APPEAL SUMMARY

| Appeal ID: 20225 | Project Address: 909-919 SW Taylor St |
| Building/Business Name: Guild Theater/Kinokuniya Bookstores of America | Fire Sprinklers: Yes - |
| Appeal Involves: Alteration of an existing structure | LUR or Permit Application No.: 18-183386-CO |

EXHIBIT B

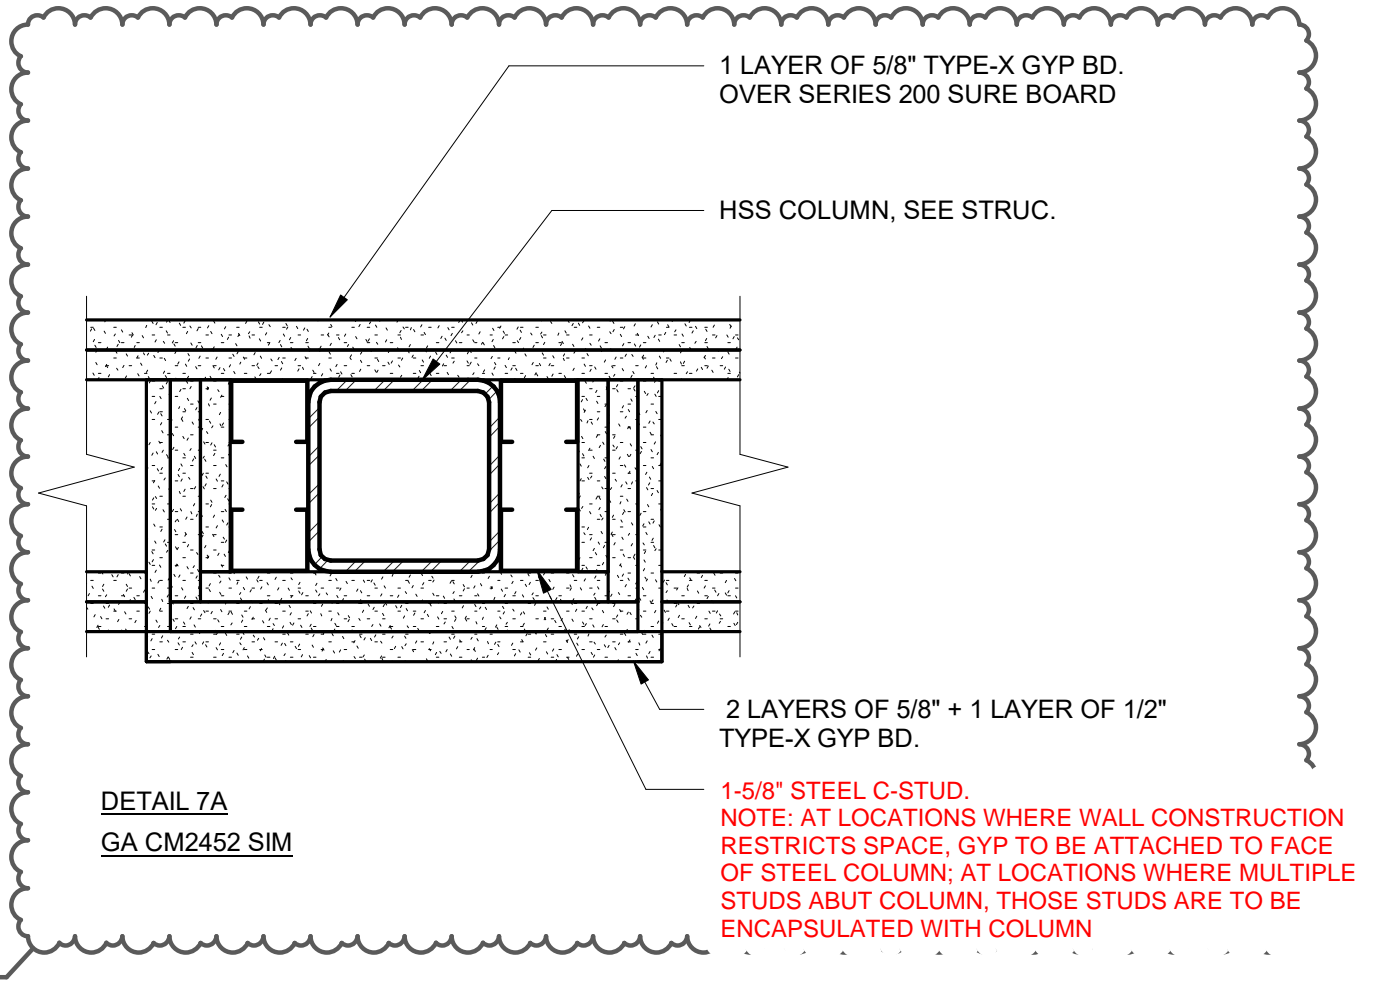
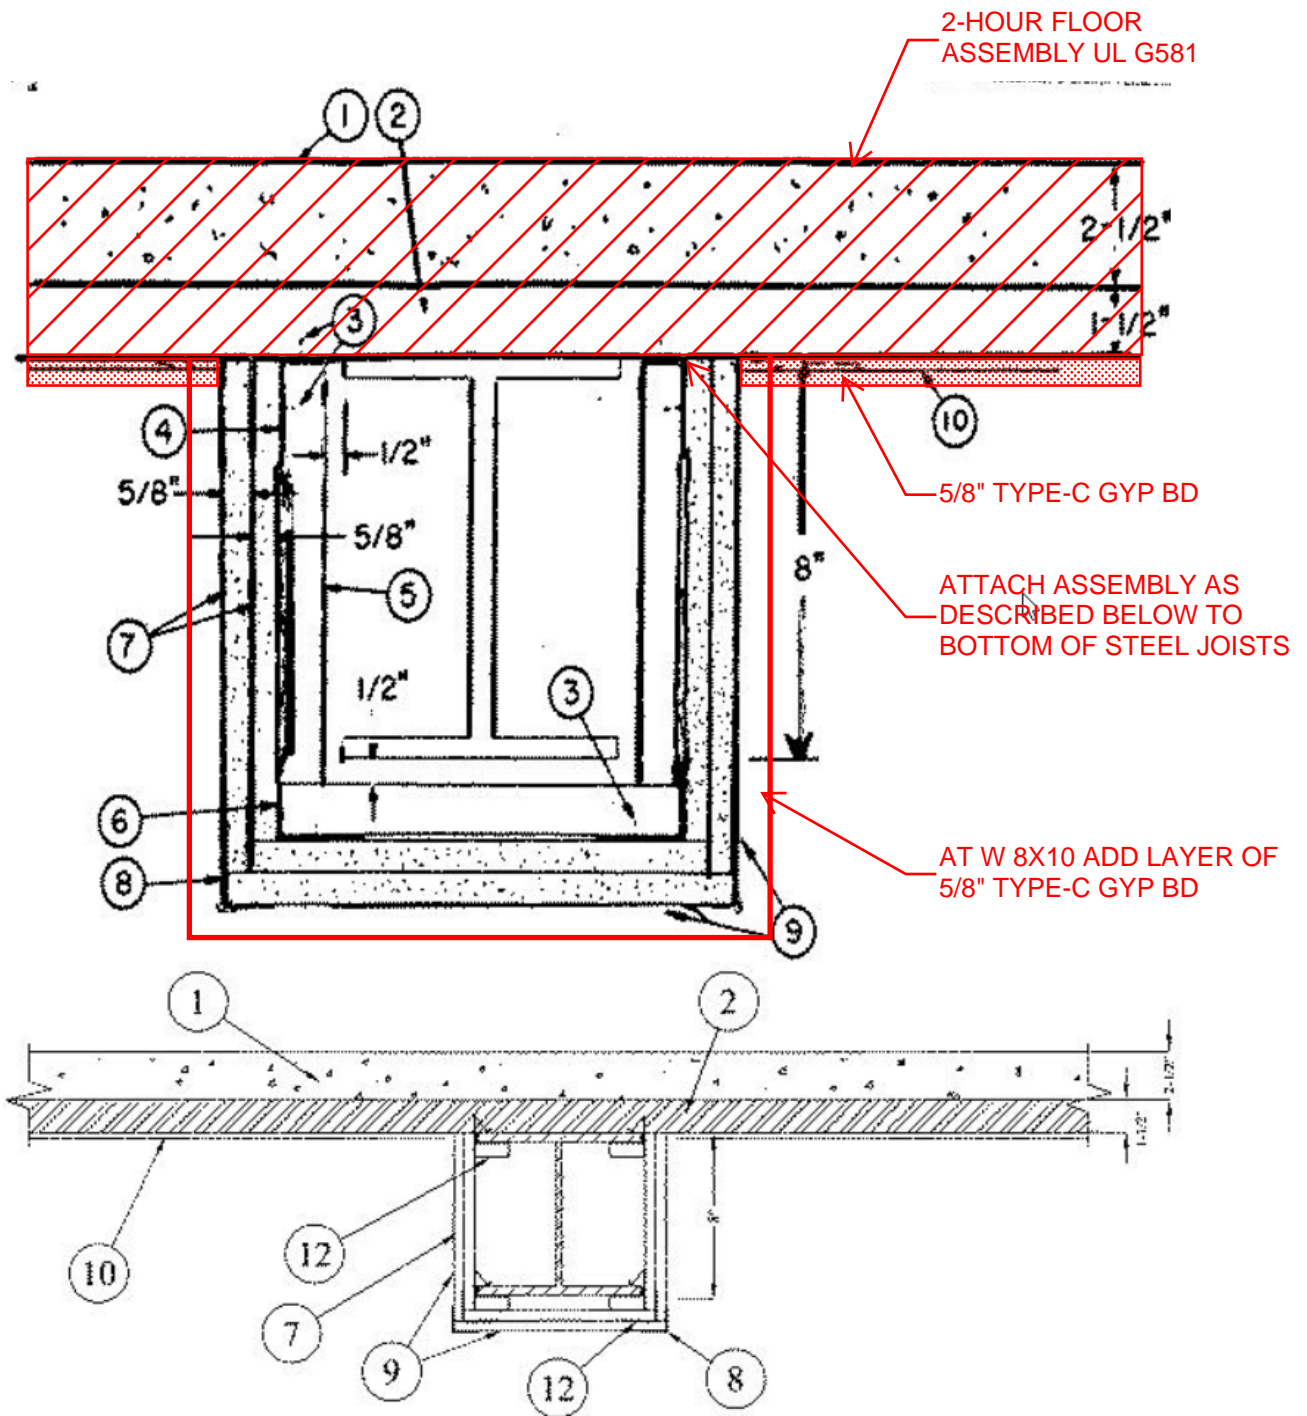
| Code Section | 704.2 Column Protection |
| Requires | Where columns are required to have protection to be fire-resistance rated, the entire column shall be provided individual encasement protection by protecting it on all sides for the full column length, including connections to other structural members, with materials having the required fire-resistance rating. |
| Proposed Design | See detail submitted as "Exhibit B". |
| Reason for alternative | This project is being constructed and is ready for gyp board immediately. The encapsulation of the columns was not captured in the permitted documents and was brought to attention by the building inspector. Columns are located in shear walls and a full encapsulation would disrupt the shear panel. Per an onsite meeting between the contractor, architect, structural engineer, plans examiner, and building inspector (as well as additional communication with the plans examiner) the submitted detail is proposed for the protection of the columns within the rated walls. The columns support the mezzanine floor only. The GA assembly calls for a 1-3/4" thickness which we are providing on three sides, and on the shear wall side we are providing 1-1/4" thickness plus a layer of metal protection. See submitted "Exhibit C" for documentation that references the fire-resistance of the series 200 Sure Board as better than standard gyp board due to the addition of metal protection. |

- 1. Reduction in bond strength of spray applied fire resistant material: Hold for additional information.**
- 2. Alternate 2 hour beam encasement: Granted as proposed.**
- 3. Alternate 2 hour UL beam assembly: Granted as proposed.**

EXHIBIT D

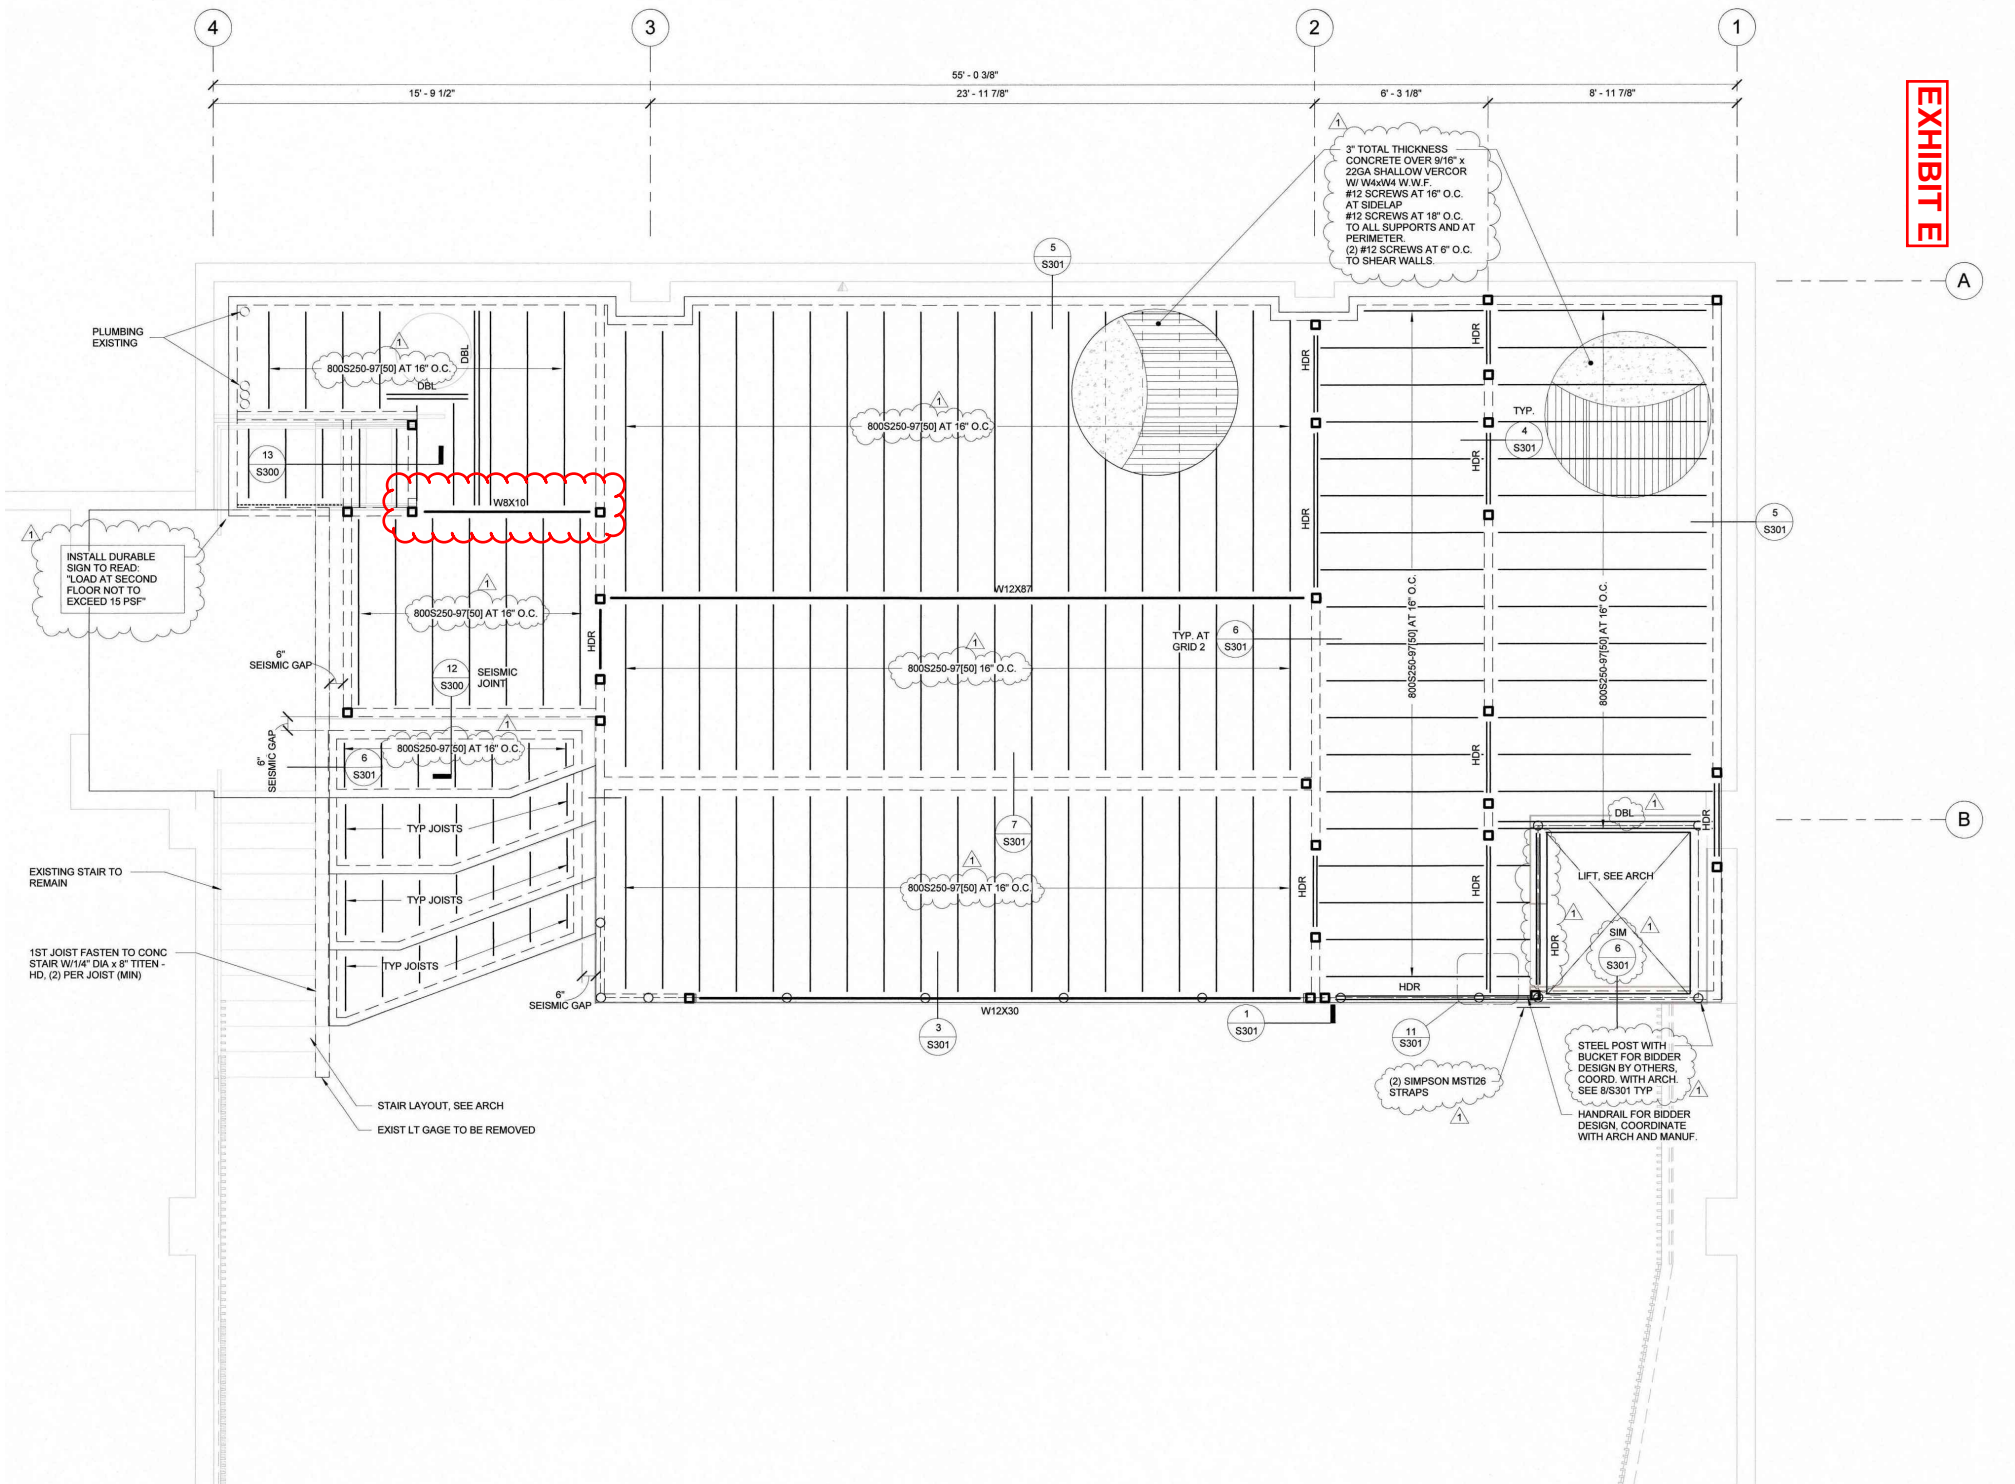
| Code Section | UL N501 |
| Requires | Encasement of beams below the floor assembly. |
| Proposed Design | See submitted "Exhibit D" |
| Reason for alternative | A modification of the UL N501 design is proposed to encase beams in the floor assembly of the mezzanine. This encasement is per the GA Fire resistance manual for beams that project more than 6" below the plane of the ceiling. Beams are not subject to OSSC section 704.3 as they support only one floor. There is one beam that is W8x10 and this size beam is not addressed by any UL assembly. We propose adding one additional layer of Type C gyp board to encase the W8x10 beam. This particular beam has a very limited tributary area (see "Exhibit E" structural plan view) and we believe the additional layer of gyp bd compensates for the smaller beam size. Beams ends will be captured within 2-hour column and wall assemblies. |
